Project	Proposed Solar Farm and BESS – Land off Main Road, Kelham, Nottinghamshire	Document No	153626-005-03
Subject	Technical Note – Response to Consultation Responses from Nottinghamshire County Council Highways and National Highways

Overview

Nottinghamshire County Council Highways Consultation Response 31/10/2023

Client	
Sirius Planning Ltd	
Project Title	
Main Road, Kelham, Newark-on-Trent	
Drawing Title	
Visibility Splays from Proposed Access	
Scale	Drawn By
1:500	LY
Drawing Size	Checked By
A1	KS
Date	Approved By
June 2023	KS
Drawing Number	Rev
153626-002	C

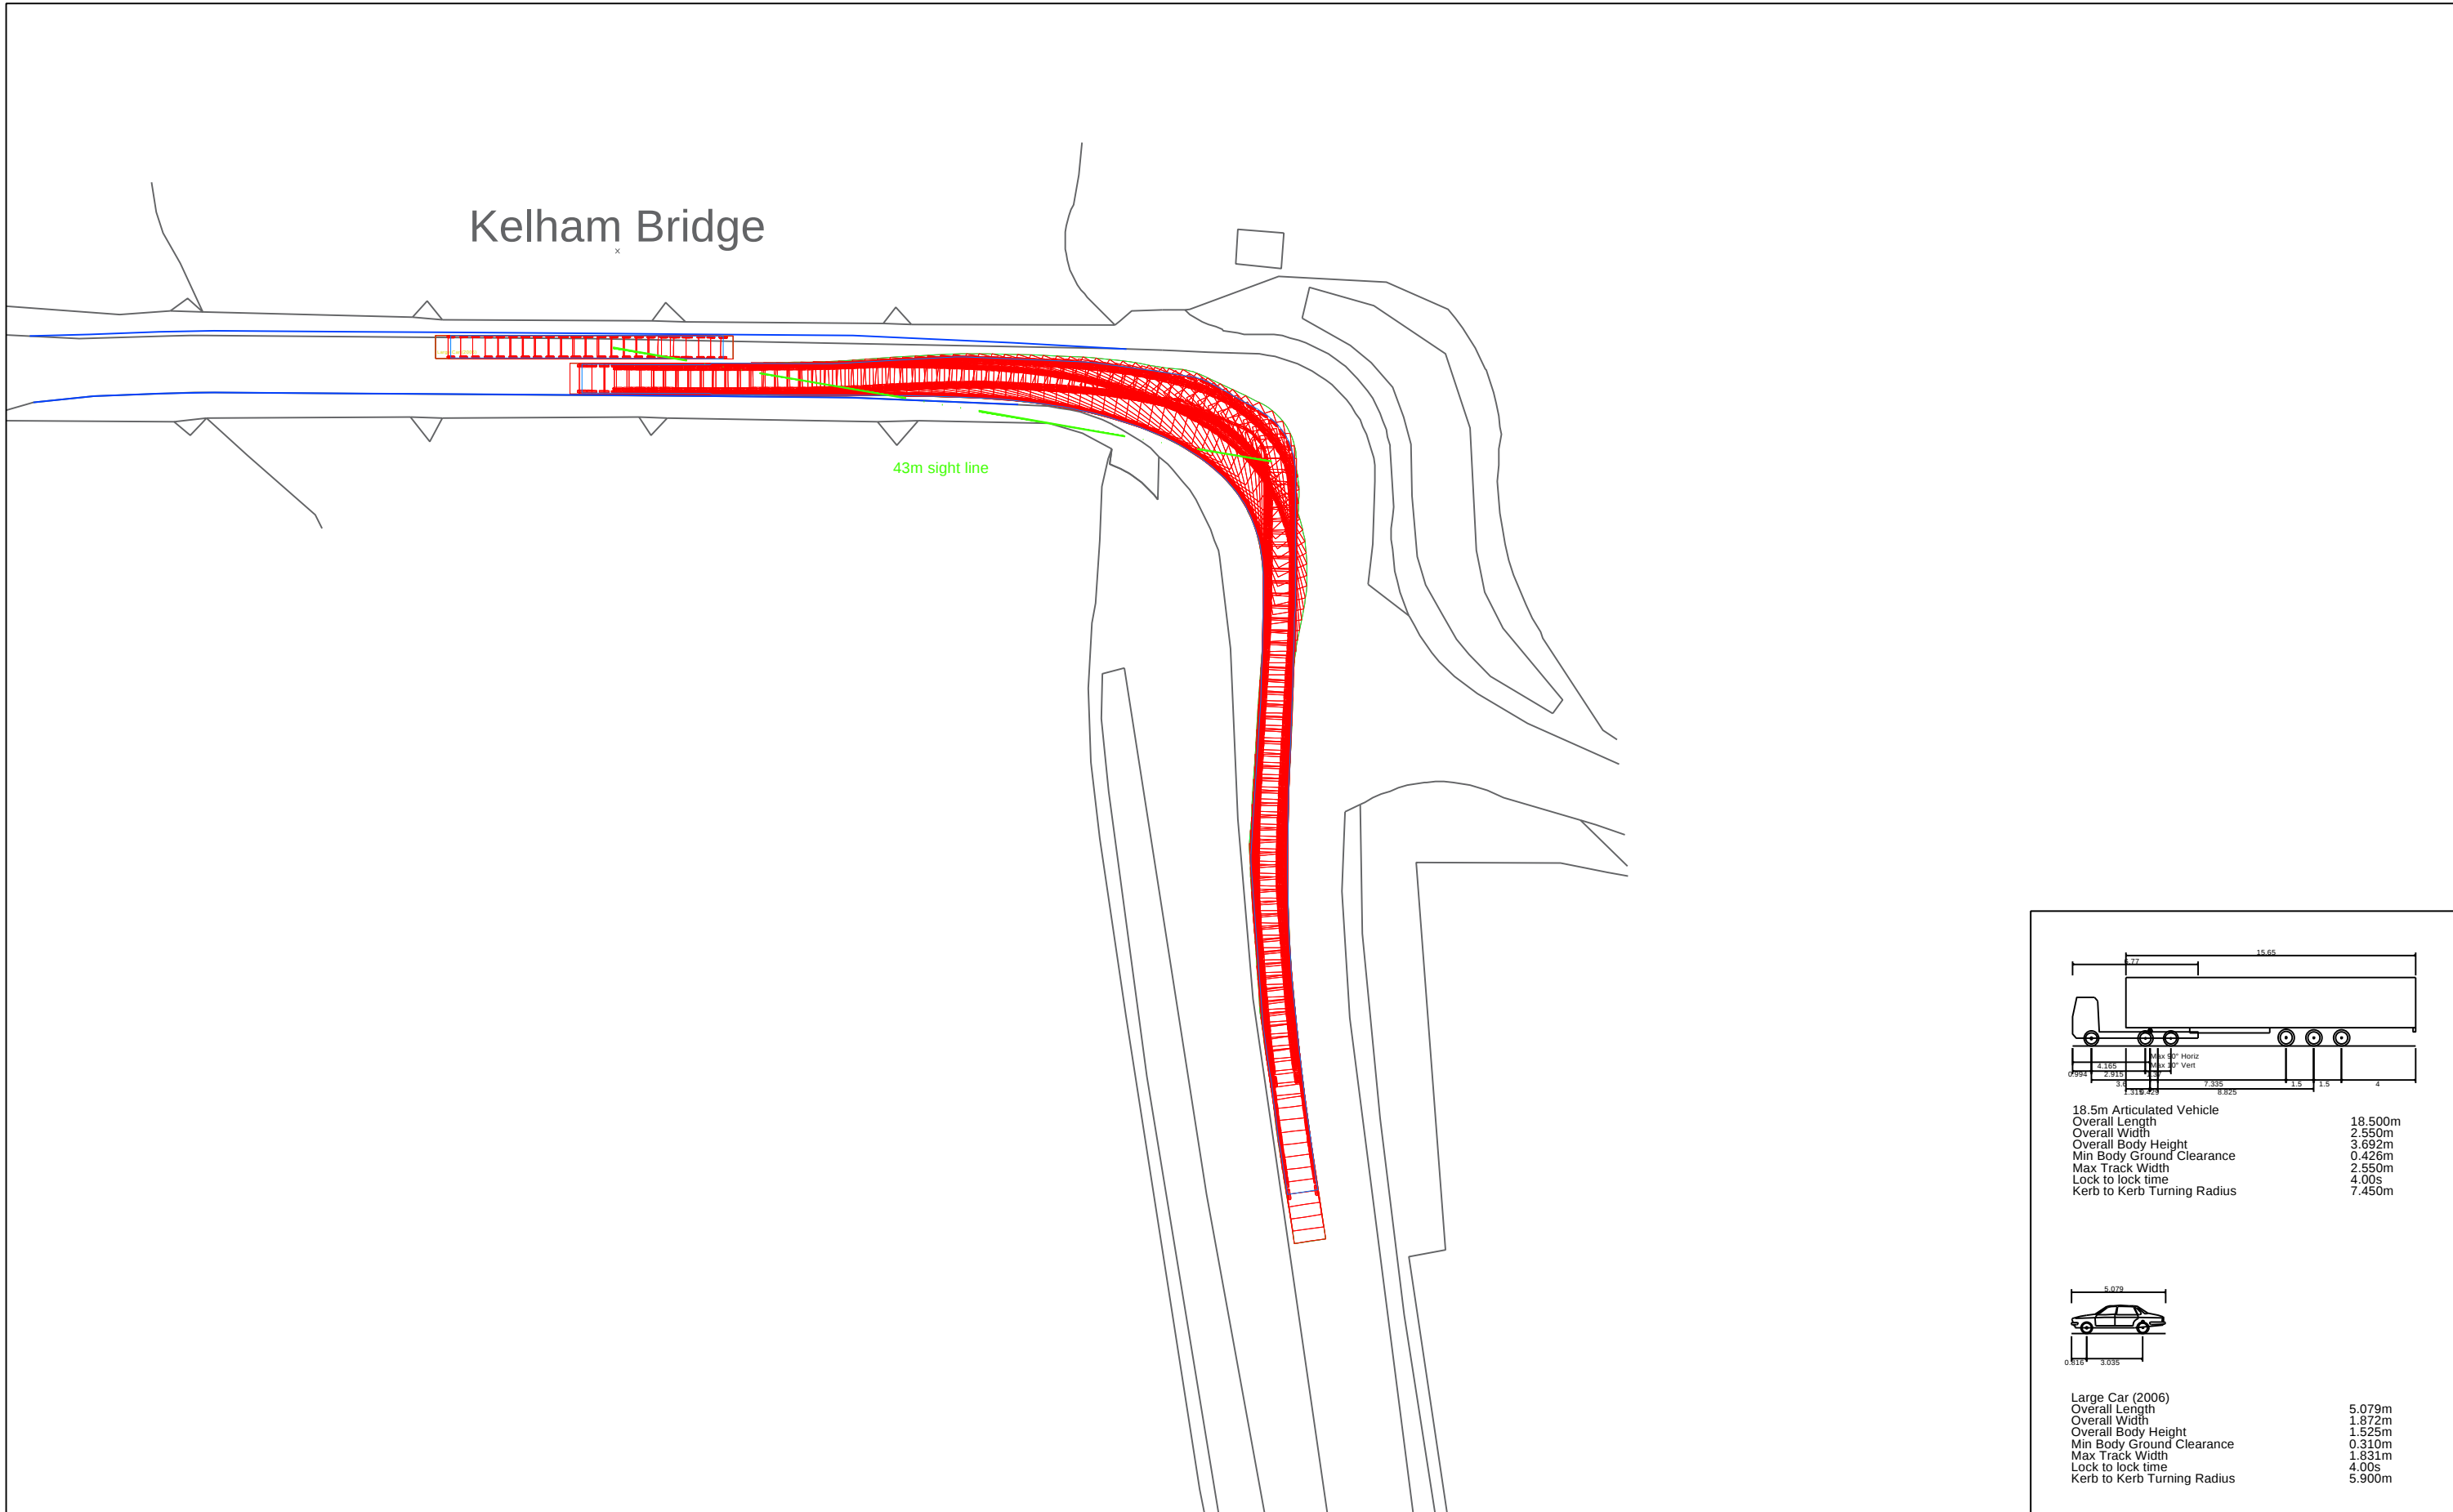
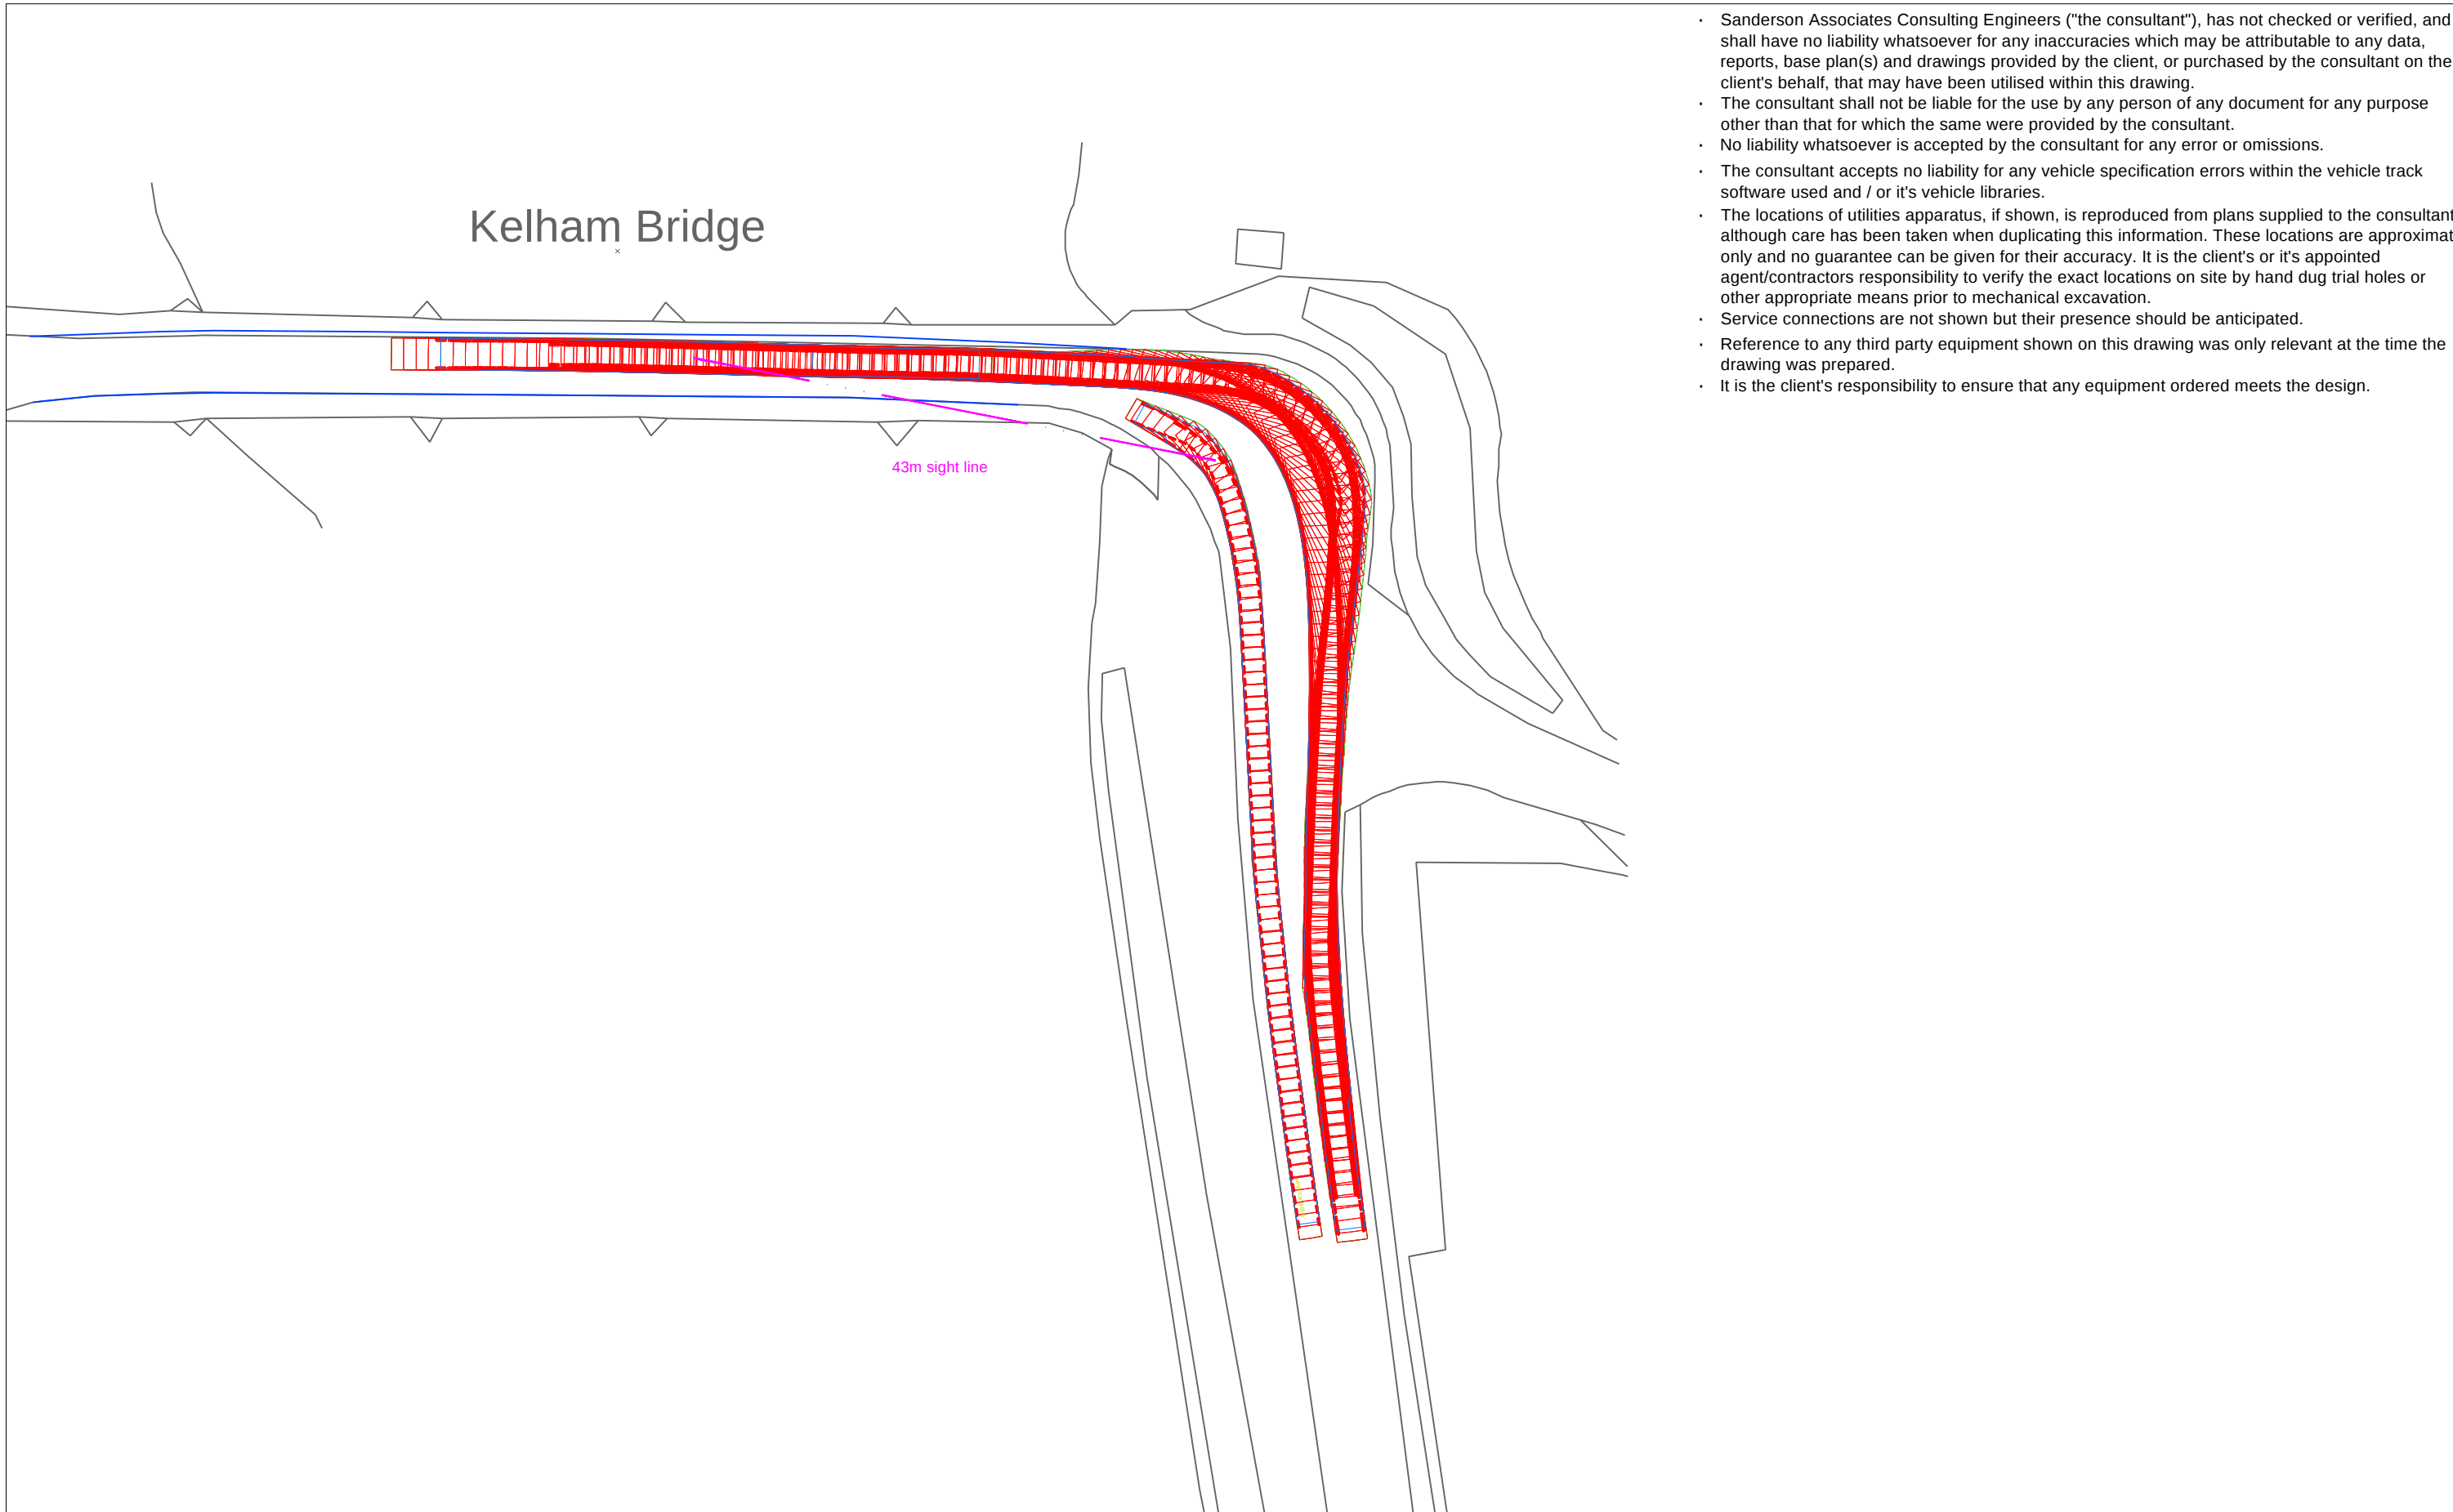
- Visibility splays to full DMRB standards should be provided

The applicant should reassess the site access design, and/or its location, to provide a scheme which meets the necessary visibility splay requirements (2.4m x 160m visibility splays) without reducing the speed limit on the A617. An alternative location for the proposed site access could be considered. This may be further north along the A617 rather than, as shown, on the inside of the bend on the A617 which exacerbates the impact of visibility splays on the hedgerow. Such an alternative location may reduce the extent of impact on the existing roadside hedgerow. Opportunities for planting new hedgerows behind the necessary visibility splays should also be considered.

Drawing 153626-002 Rev C, also attached at Appendix C, sets out revised visibility splays which meet the DMRB CD109 standards of 2.4m by 160m which are commensurate with the 50mph posted speed limit.

The translocated hedge is also shown on Drawings 153626-001 Rev C and 153626-002 Rev C for clarity.
